ADDITIONAL INFO WITH
RESPONSE TO QUESTIONS CONCERNING THEIR
ANALYSIS OF THE TMI-1 REACTOR BUILDING
SPRAY SYSTEM.....2 PG
18 ENCL

Three Mile Island Nuclear Station Unit 1 (TMI-1)
Operating License No. DPR-50
Docket No. 50-289

By letters dated October 13 and November 12, 1975, Metropolitan Edison Company transmitted the results of our analysis of the TMI-1 Reactor Building Spray System. Your letter dated January 20, 1976 requested additional information be provided to permit completion of your review on this subject. The specific information requested and our response are contained below. *

FIGURE 1
 METROPOLITAN EDISON COMPANY
 THREE MILE ISLAND NUCLEAR STATION - UNIT 1
 SCHEMATIC OF DECAY HEAT AND REACTOR BUILDING SPRAY SYSTEMS

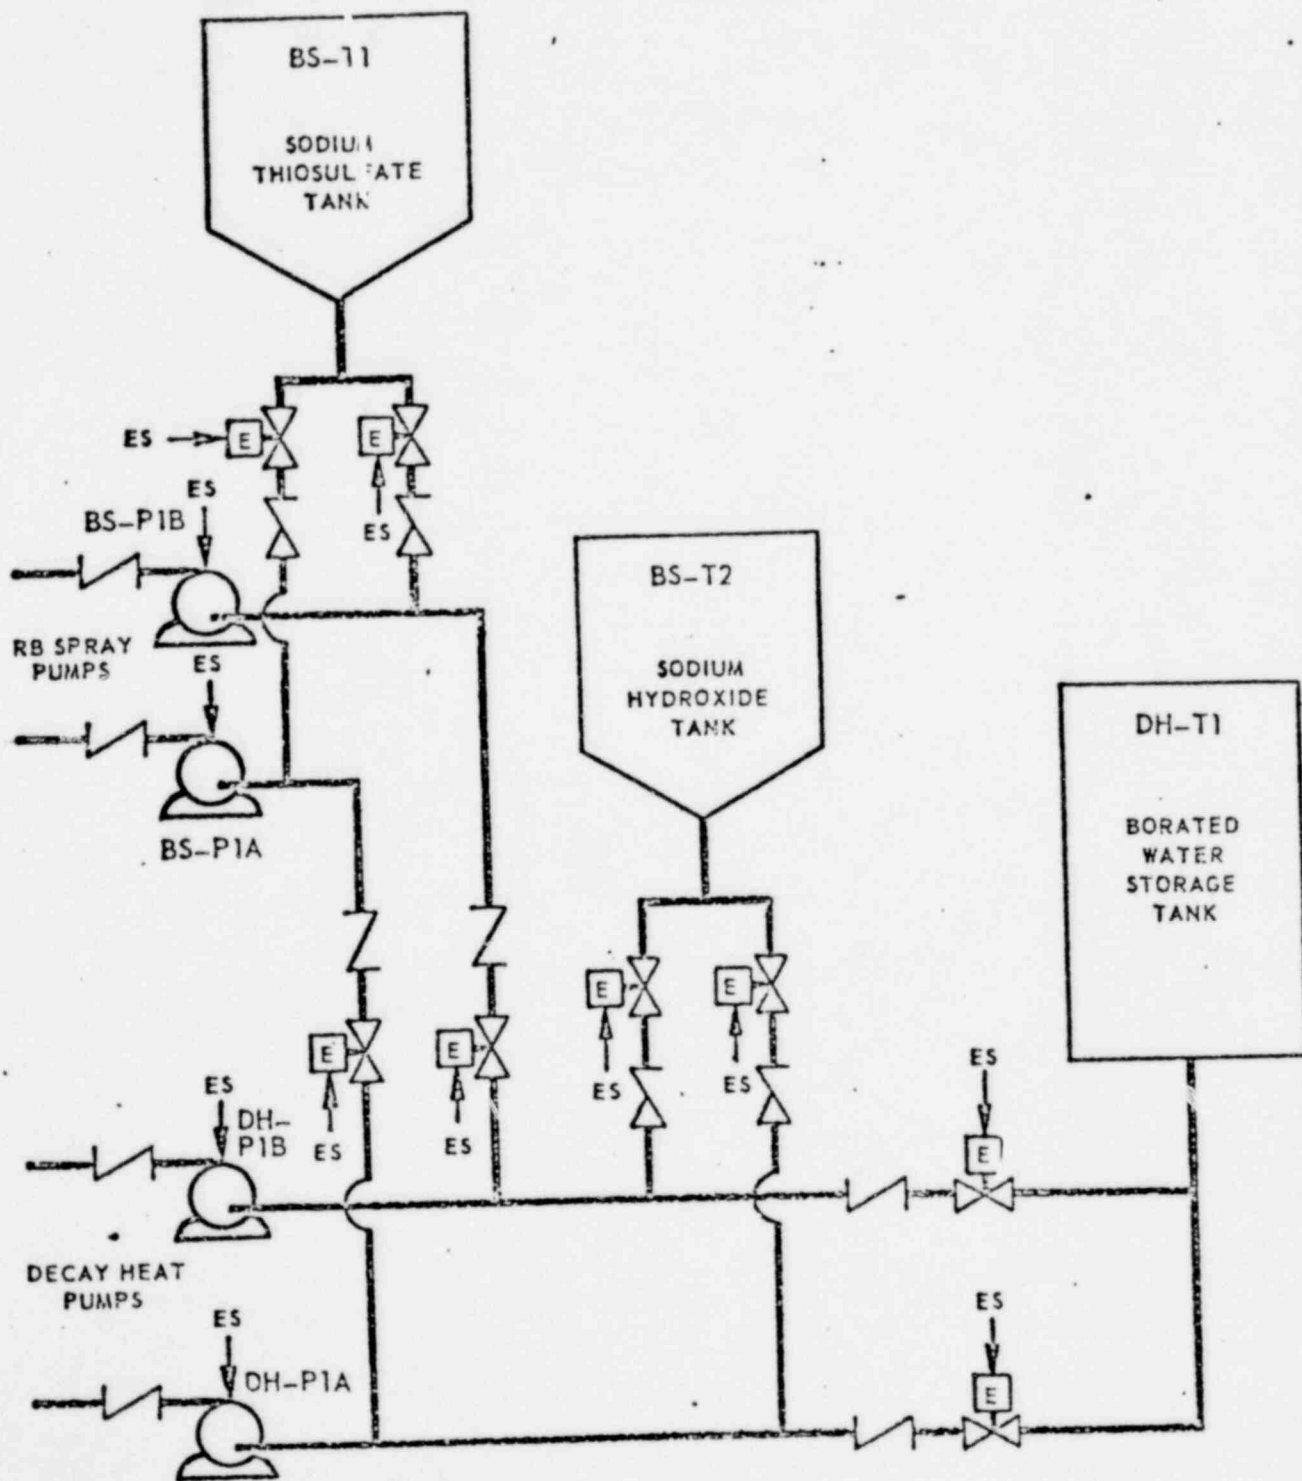
3. Provide system drawings showing the elevation of the chemical tanks, BWST and connecting piping.

Response: Figures 1, 2 and 3 of Attachment #1 provide the schematic arrangement of the TMI-1 tanks and connecting piping. Table A-I of Attachment 1 provides the elevation information requested as well as other pertinent information for each node or section of pipe identified on the above figures.

FIGURE II
 METROPOLITAN EDISON COMPANY
 THREE MILE ISLAND NUCLEAR STATION - UNIT 1
 MODEL OF DECAY HEAT AND REACTOR BUILDING SPRAY SYSTEMS
 FOR FULL FLOW DRAWDOWN ANALYSIS

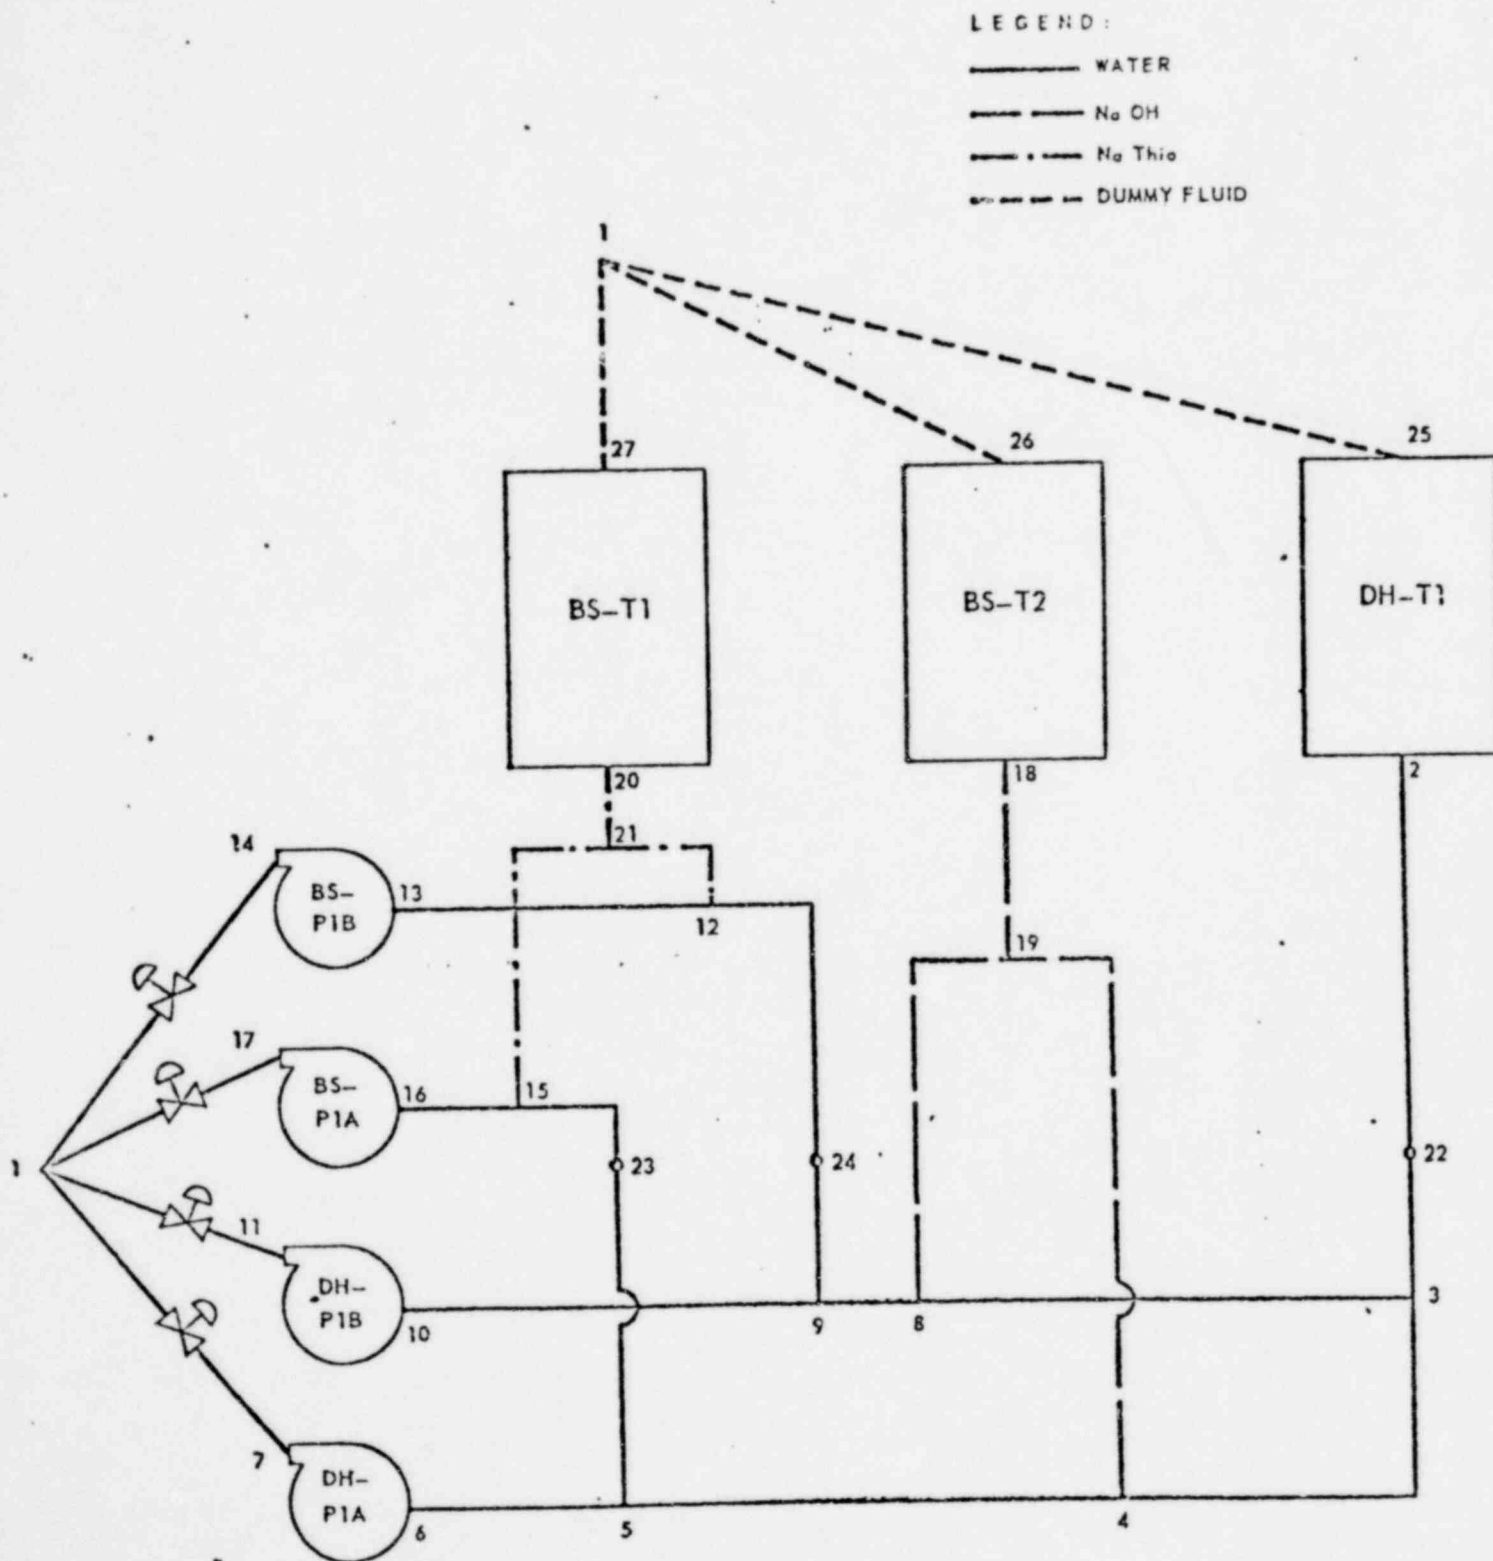
2. Describe and justify the methods used for determining the static pressure head due to the liquid in the BWST, the aspiration force in the spray lines at the chemical tank discharge points, and the friction forces involved.

A comparison of the observed and calculated results of the full flow test is presented in Table I and Figures IV a, b, c. The computer model is shown in Figure II. The calculated level drop per five minutes was comparable to that observed for the three tanks. It should be noted that since a steady state analysis is being done, there exists a larger discrepancy between the observed and calculated results during the startup of the test. The discrepancy at the end of the test is due to the manner in which the liquid levels were recorded; the automatic print-out device used was set to record the levels every five minutes. When the LO-LO level alarm in the BWST was tripped, the pumps were throttled to terminate the test. The liquid levels and time were not recorded; the levels were recorded at the end of the five minute interval, thereby causing the tail-off shown in Figures IV a, b, and c. Test personnel stationed by the pumps heard no indication of cavitation or vortexing during the tests.
